AEROSPACE FUSELAGE SKIN PANEL

RT PLAN — ⚠ OVERSIZE PART

APC-RT-006-E

PLAN VIEW — FULL PANEL

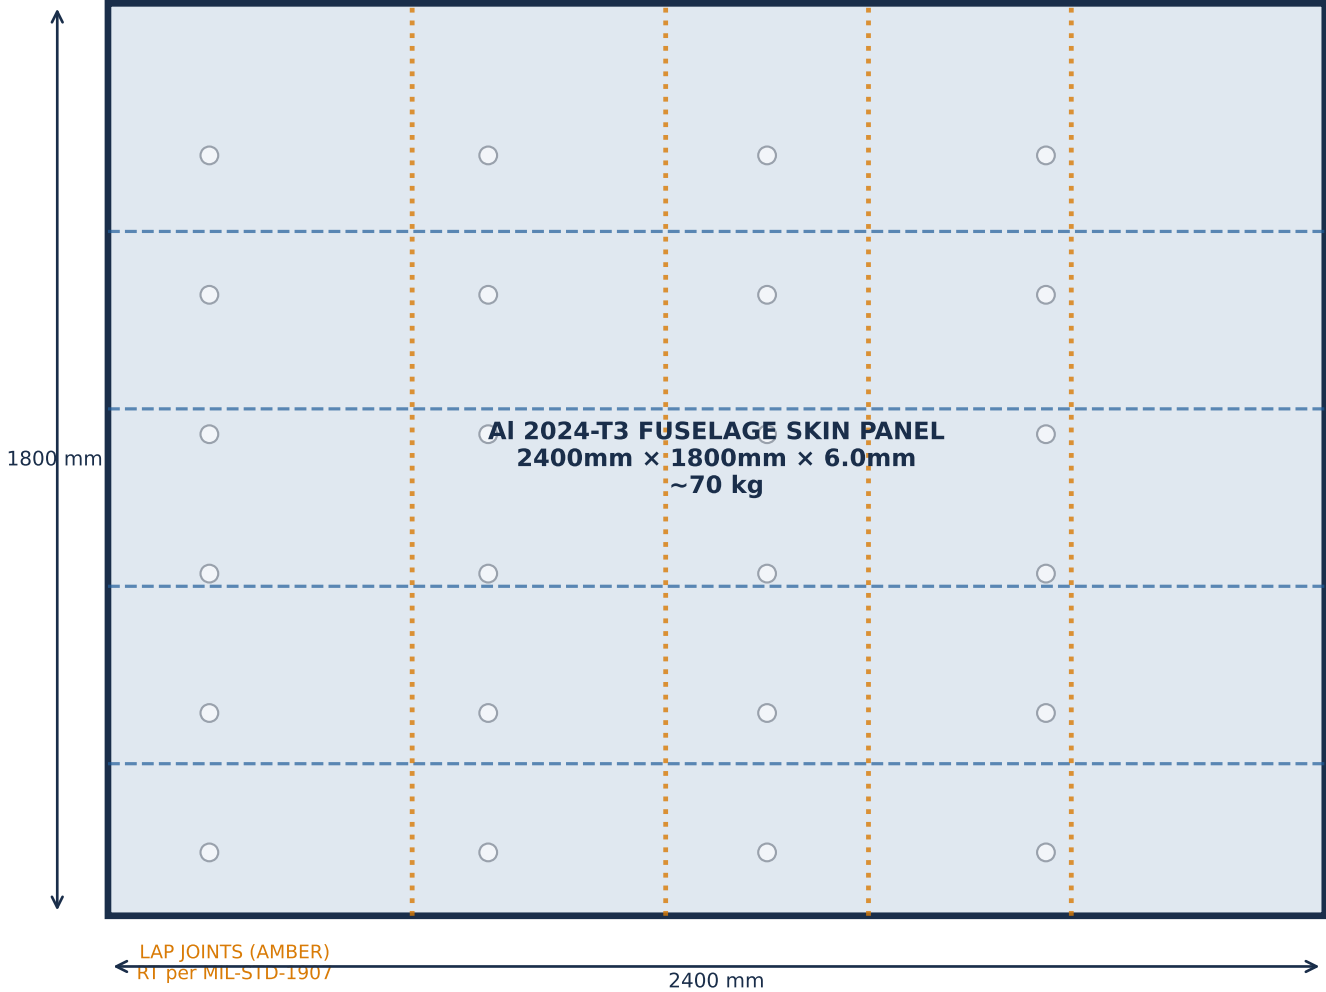
⚠ CAUTION: PART DIMENSIONS (2400 × 1800 mm) EXCEED ALL CABINET AND WALK-IN MACHINE ENVELOPES ⚠

MACHINE	MAX L (mm)	MAX W (mm)	FIT?
UNIT-2 Comet MXR225	600	600	✗ NO
UNIT-3 Comet MXR320	600	600	✗ NO
UNIT-1 Varian Walk-In	1526	1200	✗ NO
UNIT-4 Varex NDI320	1526	1200	✗ NO
REQUIRED	2400	1800	—

1. Part too large for ANY on-site machine
2. Per ASME RT — panel segmentation NOT permitted
3. Outsource vendor must be NADCAP-certified
4. Report to NDT Supervisor before proceeding
5. Approver: Marcus T. Hoffmann
6. Email: m.hoffmann@aeroprecision.com Ph: 713-445-8856
7. Drawing ITAR-controlled — DISTRIBUTION D LIMITED

1. Outsource to OEM crawler-track system (>3000mm)
2. Section panel for cabinet RT (design change)
3. Request ROTO-XRAY ROBOT approval (PER SE-999)
